SERVICE BULLETIN

Product: CRT MONITOR
Model: AQ17HS/IS, AQ19IS/MS
 SyncMaster 700IFT, 750P, 900IFT, 950P

Bulletin No.: MON02-001 (01-C/M-E0050)
Bulletin Date: October 24, 2001
ECN Date: October 24, 2001

SUBJECT: DY-Wire Clamp Change

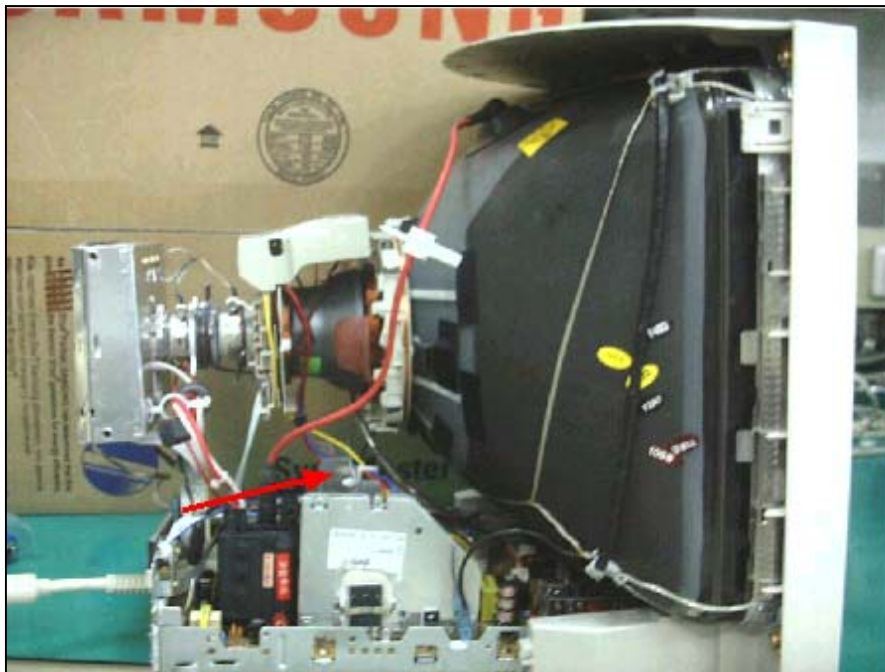
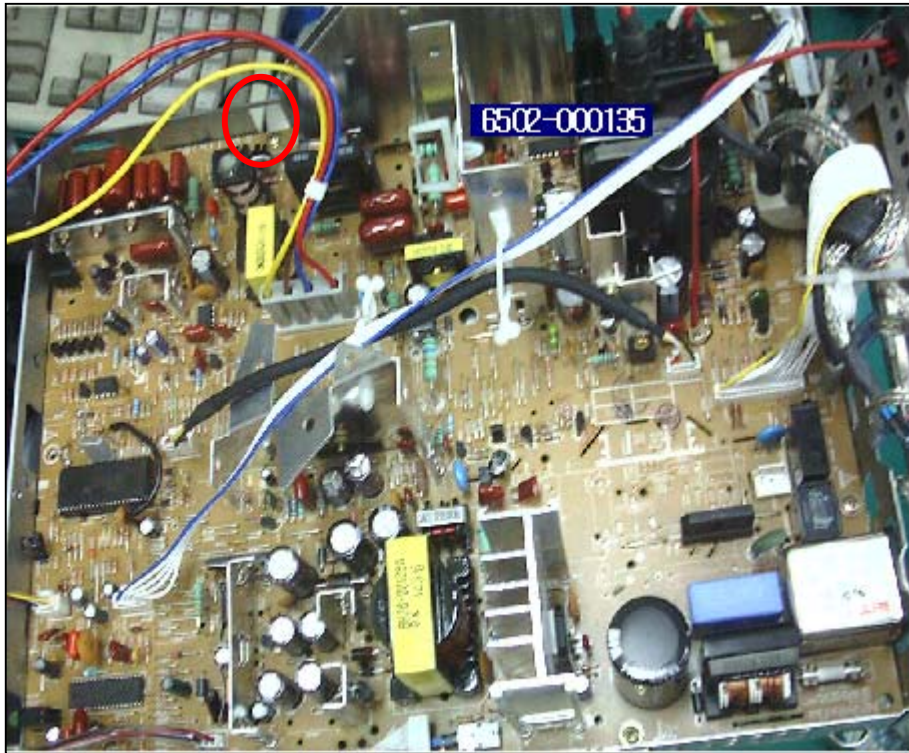
Background: The DY-Wire of the SyncMaster 700IFT, 750P, 900IFT, and 950P CRT monitors can cause arcing and other damage.

Cause: The DY-wire can touch the sharp edge of the high voltage FET heat sink. This can cause the wire shield to peel off thus causing an arc.

Solution: Change the routing method and clamp shape. This should be checked on all monitors manufactured before November 2001. (Refer to pictures on page 2 and 3).
